**DETAILED ACTION**

Claims 1-15 are rejected under 35 U.S.C. 102(b) as being anticipated by patent 639220 to Slater et al.

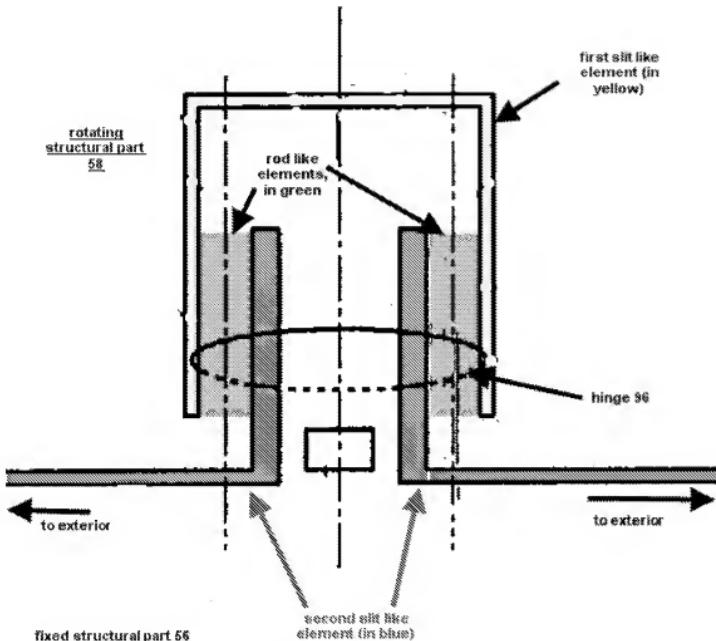
Regarding claim 1, Slater discloses an elastic hinge formed into a monolithic structure (abstract), whereby the elastic hinge 96 separates the monolithic structure in a rotating structural part (58) and a fixed structural part (56), and whereby the elastic hinge 96 allows rotation of said rotating structural part (58) relative to said fixed structural part (56, abstract), said elastic hinge being formed by forming at least one first slit-like element (102) into said monolithic structure, whereby the or each first slit-like element (102) defines the elastic hinge 96 and thereby at least one rotation axis (Y) of the elastic hinge, characterized in that at least one rod-like or plate-like element (106) is formed into said monolithic structure by forming at least one second slit-like element (L shaped slit in figure 4a) into said monolithic structure. See figure below for clarification.

Regarding claim 2, Slater discloses the structure of claim 1, characterized in that the or each first slit-like element (102) comprises at least two segments (three segments making a U shape, figure 4a, shown above) defining a plane (X-Z), whereby the or each second slit-like element (L shaped slits) runs approximately in parallel to one segment of a corresponding first slit-like element (102) thereby defining a rod-like or plate-like element (green area, 106).

Regarding claim 4, Slater discloses the structure of claim 1, characterized in that the or each first slit-like element (102) comprises at least two segments, whereby a first segment runs in the direction of a first axis (X) and a second segment runs mainly in the direction of a second axis (Z) being perpendicular to said first axis (X), and whereby the rotation axis (Y) of the elastic hinge runs in a direction perpendicular to said plane (X-Z) defined by the first axis (X) and the second axis (Z), shown in the above figure.

Regarding claim 5, Slater discloses the structure of claim 1, characterized in that the or each first slit-like element (102) is formed into said monolithic structure in a way that the or each first slit-like element (102) does only extend to the exterior of the monolithic structure in the direction of the rotation axis (Y) of the elastic hinge, whereby the first slit-like element (22) is completely surrounded by the monolithic structure in the direction of the axis (X, Z) defining said plane (X-Z). The first slit, as shown above, does not extend to the surface of the monolithic structure.

Regarding claim 6, Slater discloses the Elastic hinge according to claim 1, characterized in that the or each second slit-like element (in blue, above) is formed into said monolithic structure in a way that the or each second slit-like element extends to the exterior of the monolithic structure in the direction of the rotation axis (Y) of the elastic hinge and in the direction of one axis (X) defining said plane (X-Z).
